DEPARTMENT OF TRANSPORTATION
 DIVISION OF ENGINEERING SERVICES
 Office of Structural Materials
 Quality Assurance and Source Inspection

Contract #: 04-0120F4
 Cty: SF/ALA Rte: 80 PM: 13.2/13.9
 File #: 69.28

WELDING INSPECTION REPORT

Project Name: SAS Superstructure **OSM Arrival Time:** 630
Prime Contractor: American Bridge/Fluor Enterprises, a JV **OSM Departure Time:** 1530
Contractor: Zhenhua Port Machinery Company, Ltd (ZPMC), Changxing Island **Location:** Shanghai, China

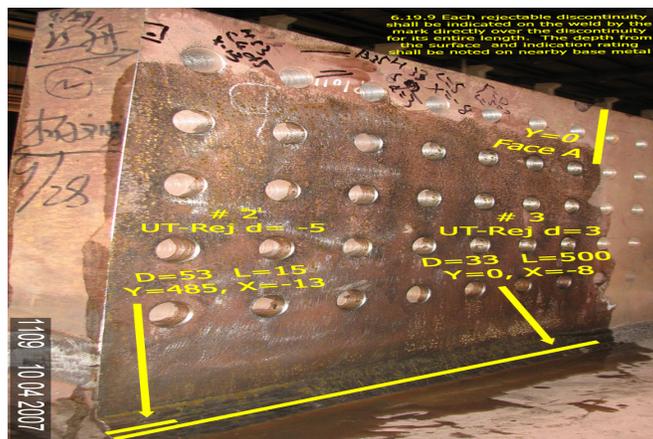
The QA inspector had a conversation with the Senior Level III John Kinsey. The QA inspector brought to his attention that ZPMC did not mark the location of the rejectable indications directly over the weld clearly with the depth and rating of the indication nearby, in addition the QA inspector relayed that the QA inspector had mentioned before to ABF and ZPMC representatives in several occasions. Mr. Kinsey relayed to the QA inspector that he would bring these issues in the ABF, ZPMC and Caltrans meeting.

The photographs below show on the left side ZPMC's actual marking and on the right side the required marking (directly on the weld) as per AWS D1.5 (2002).
